Memorandum Department of Planning & Public Works

RE: P.Z. 15-2009 Chesterfield Airport Commerce Park (Insituform Technologies Inc.): A request for a new public hearing to amend the legal description for the change of zoning from "PC" Planned Commercial District, "PI" Planned Industrial District and "M3" Planned Industrial District to a new "PI" Planned Industrial District for three tracts of land located at 17970 Chesterfield Airport Road, 609 Cepi Drive and 17975 Edison Avenue (17v240153, 17v240331 and 17v330311).

Planning Commission Vote Report

Petition: P.Z. 15-2009 Chesterfield Airport Commerce Park (Insituform Technologies Inc.)

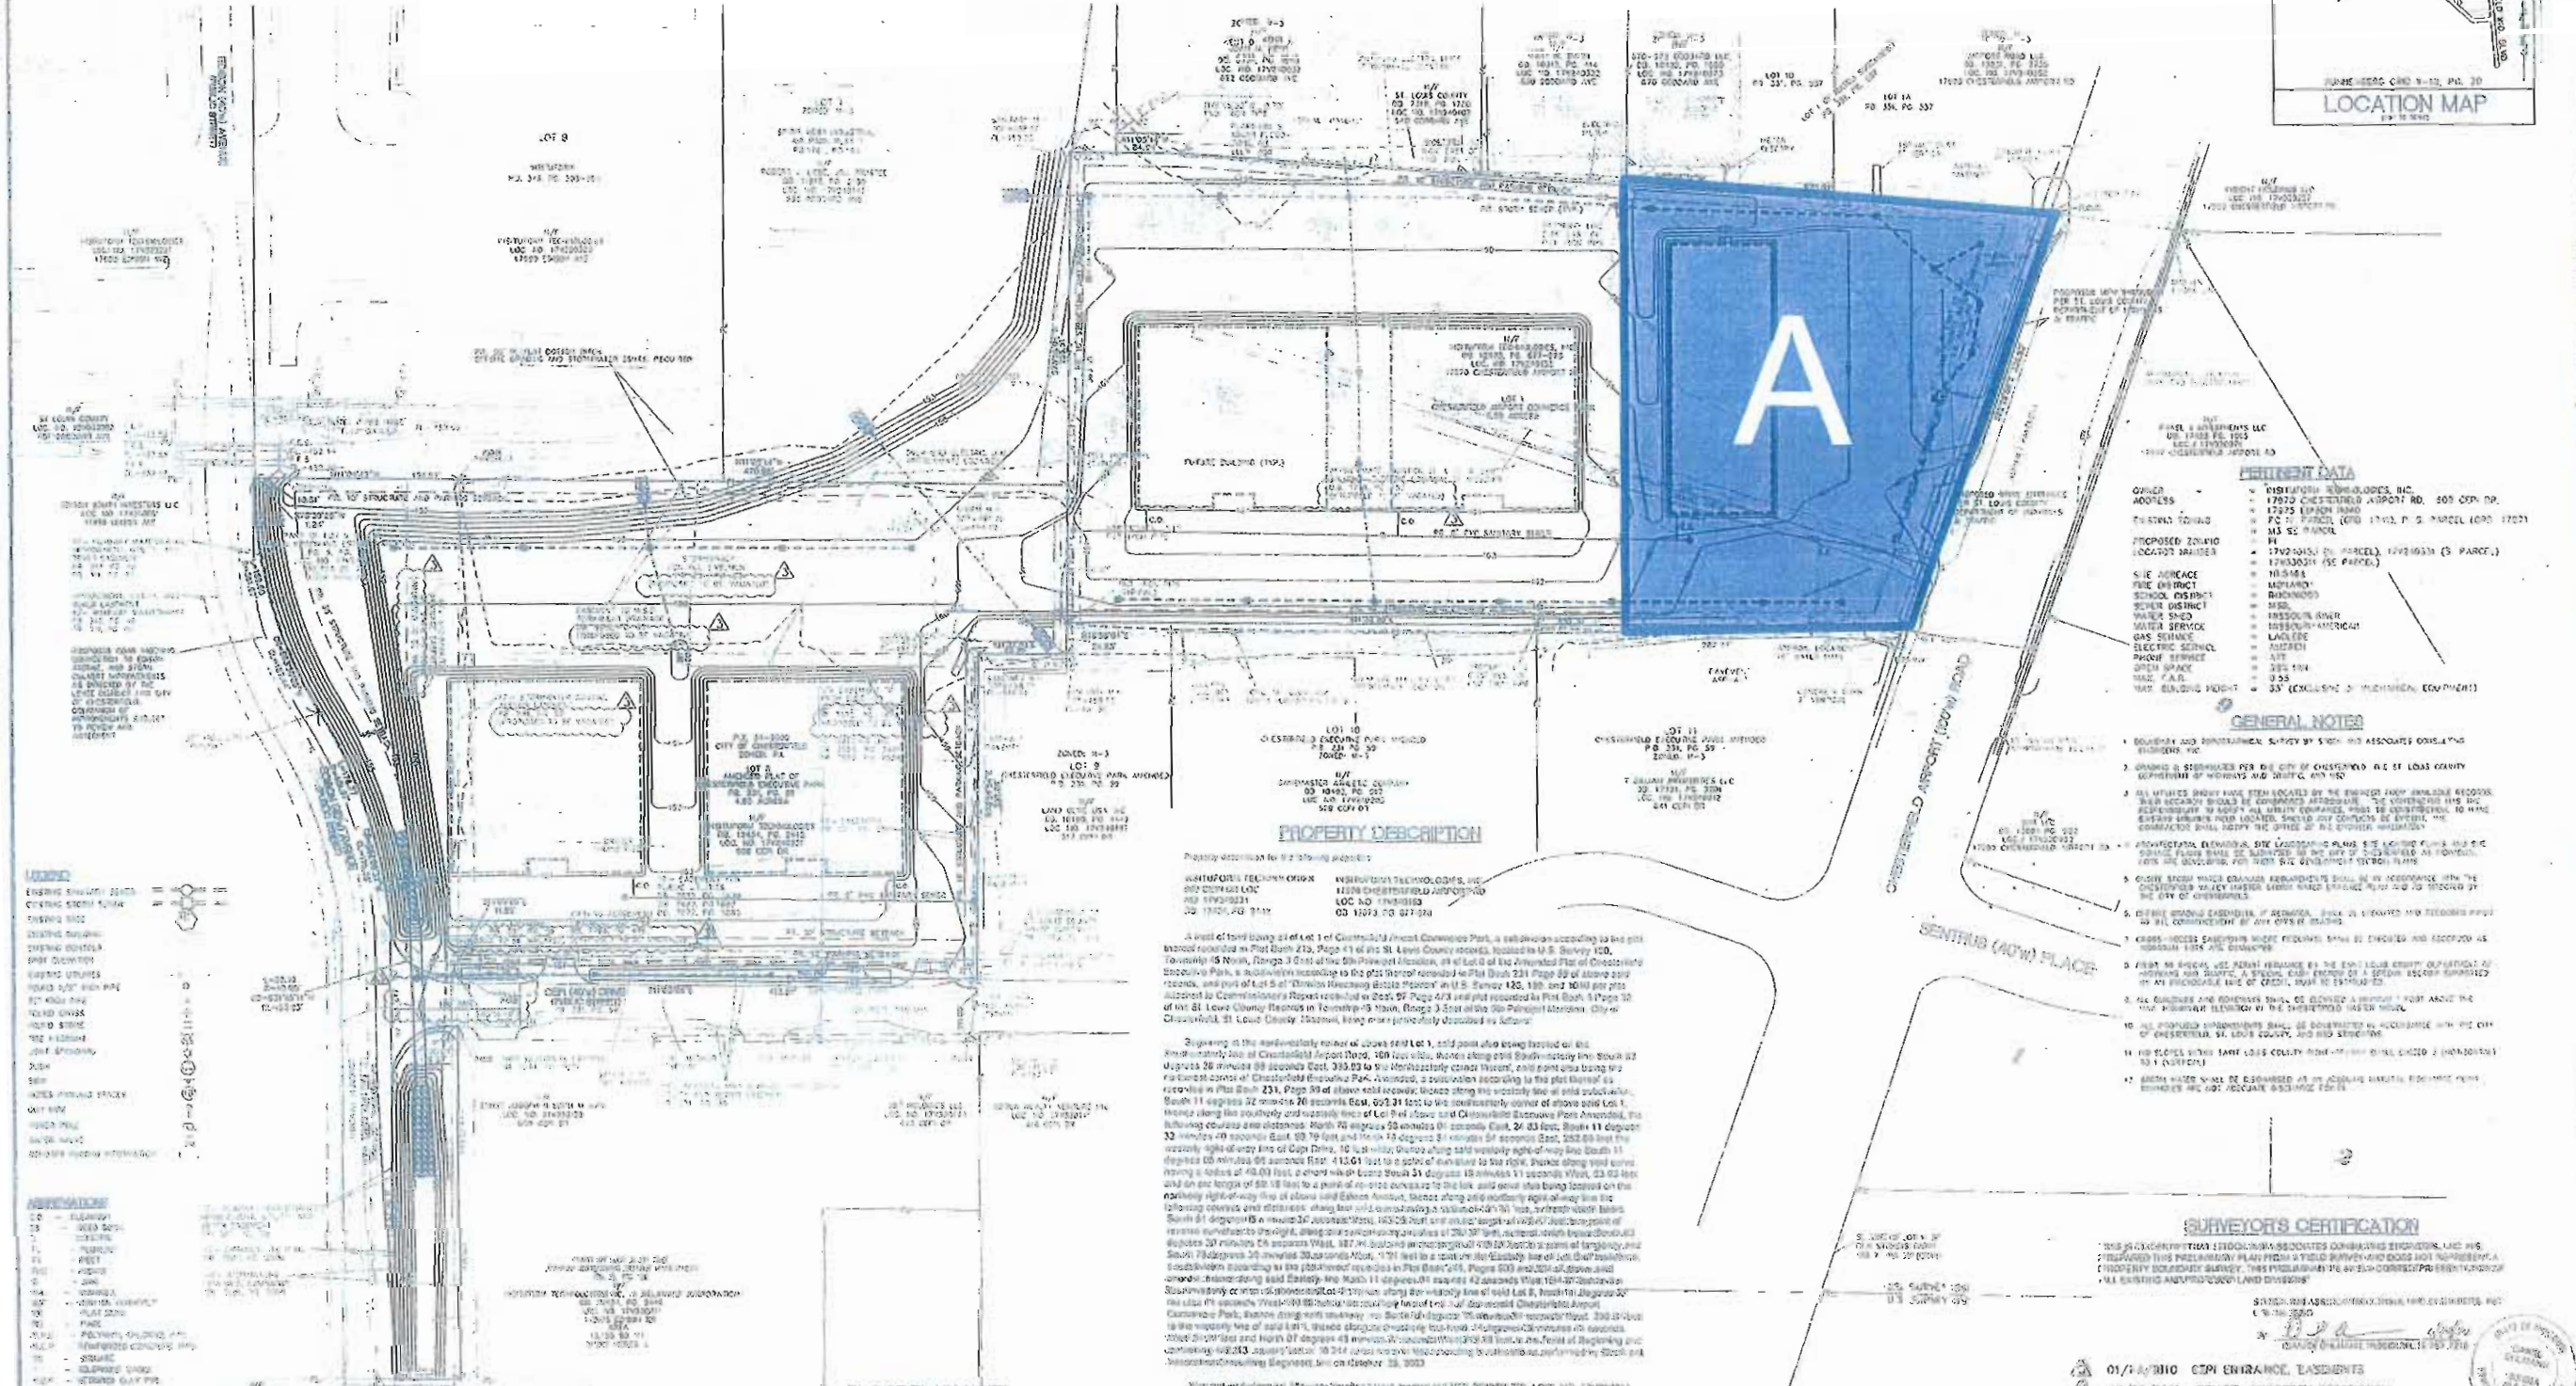
3. Planning Commission asked Staff to continue to work with the petitioner to look at uses and in particular, those uses that are being limited to Edison Avenue. The Attachment A has been revised to limit additional uses to the Edison Avenue side as shown on Exhibit 1 which is attached to the Attachment A.

2. The following uses 7, 28, 29, 32, 35, 49, 51 and 56 shall not be located in Area A as shown on Exhibit 1.

CHESTERFIELD AIRPORT COMMERCE PARK
PRELIMINARY PLAN

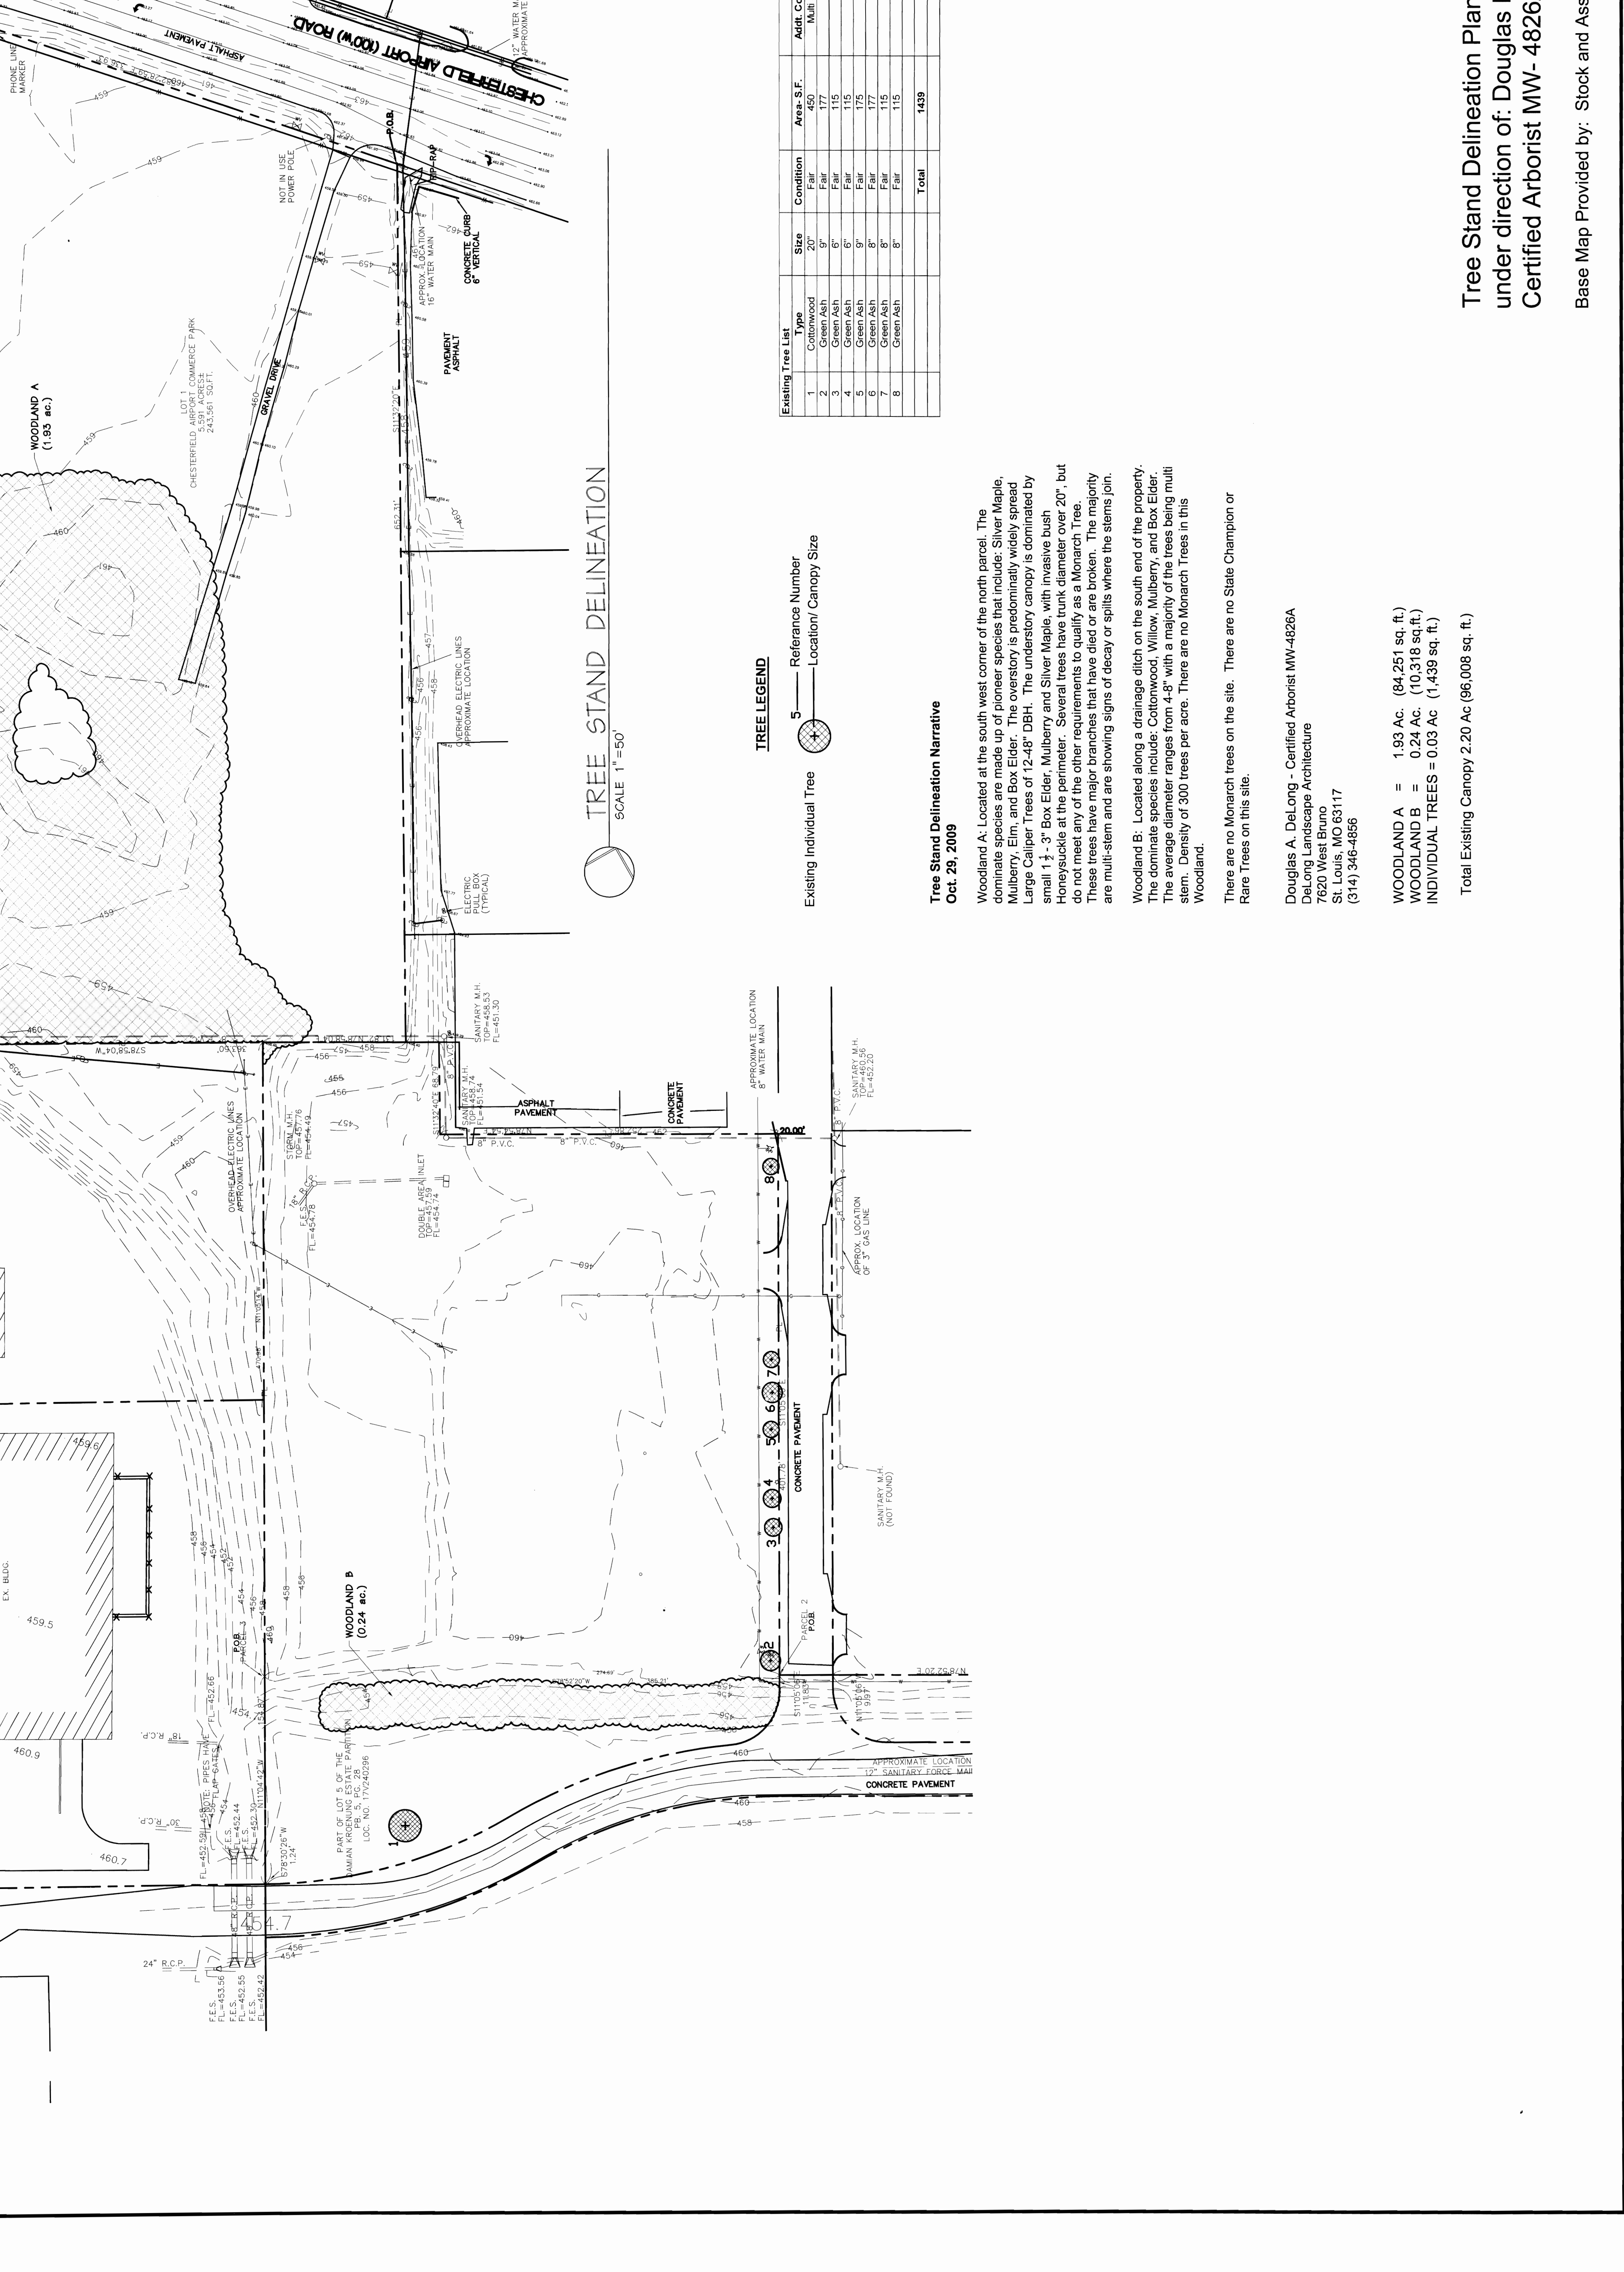
1. The petitioner was asked to revise the Preliminary Plan so that the access point(s) along Cepi Drive comply with the City of Chesterfield Access Management requirements. The petitioner has moved the drive aisle edge of the proposed southern most entrance to 100' off the proposed Edison Avenue 'edge of pavement'. Additionally, they have identified the existing driveway to be removed. These items have been revised on the Preliminary Plan.
